Re: Pilgrim Station, Application for Amendment dated May 12, 1981

Proposed Change #81-102

License No. DPR-35
Docket No. 50-293

Revised Request for Technical Specification Changes
Concerning Single Loop Operation

FIGURE 3.11-4

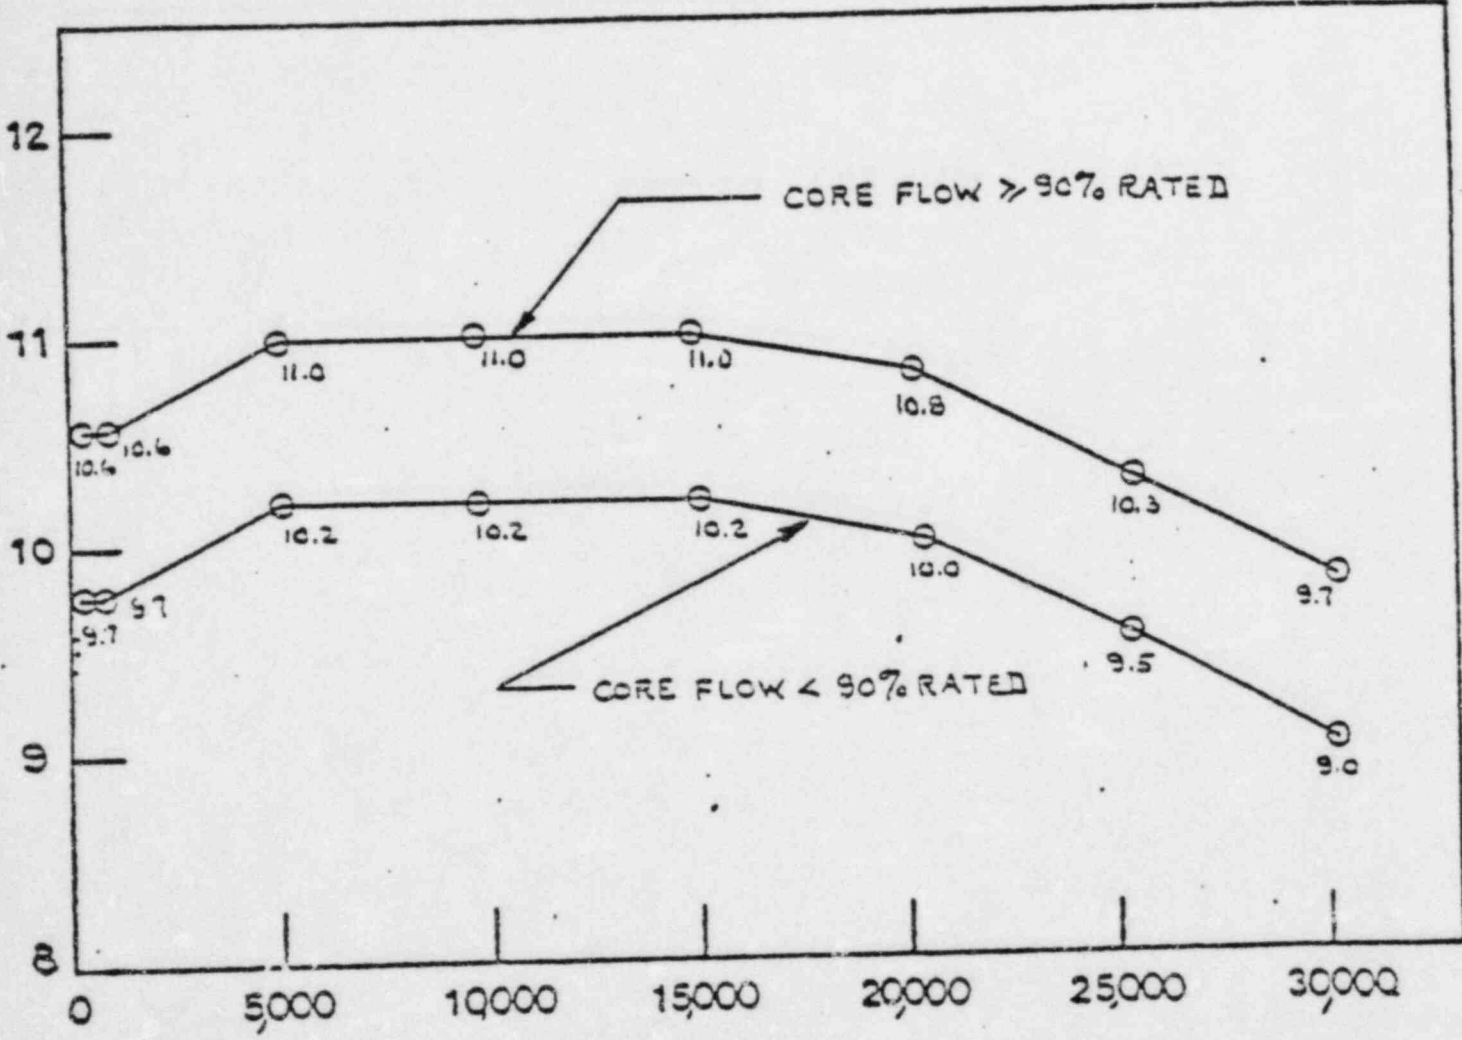
*For two recirculation loop
Reduction factors for one recirculation loop were derived in
"Pilgrim Single-Loop Operation", NEDO 24268, June 1980.

FIGURE 3.11-5
 MAXIMUM AVERAGE PLANAR LINEAR HEAT GENERATION RATE
 VERSUS

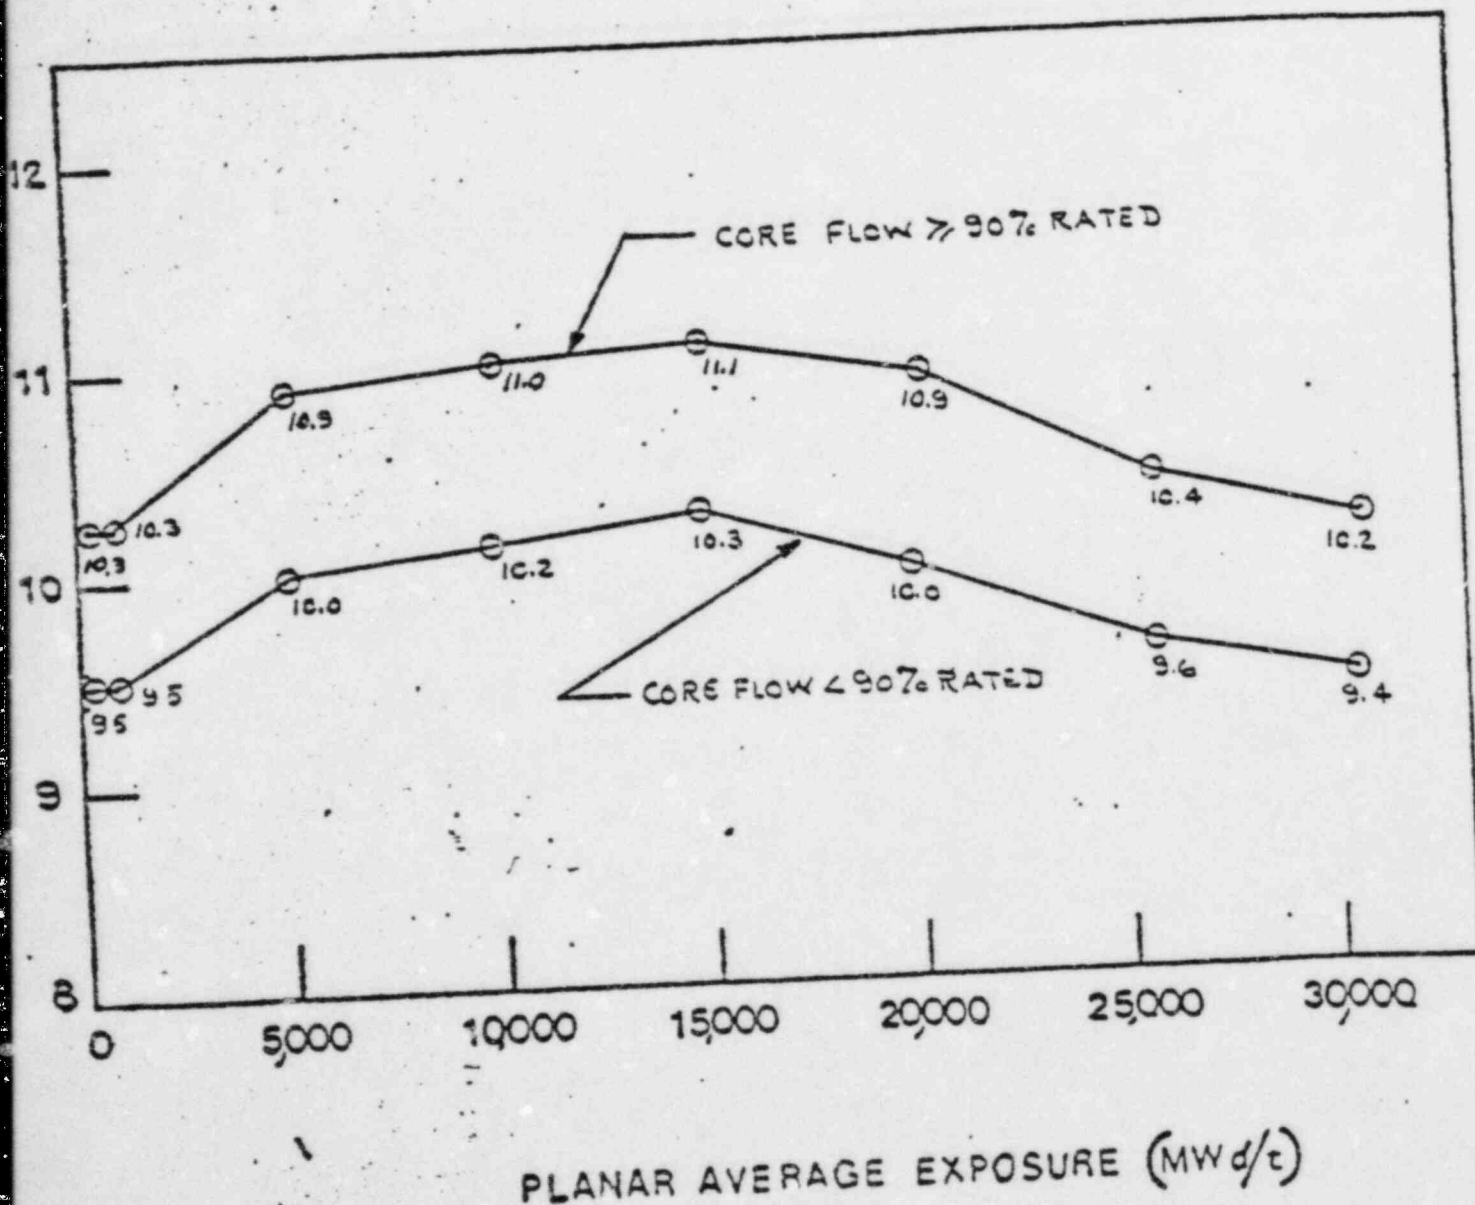
*For two recirculation loop
 Reduction factors for one recirculation loop were derived in
 "Pilgrim Single-Loop Operation, NEDO 24268, June 1980"
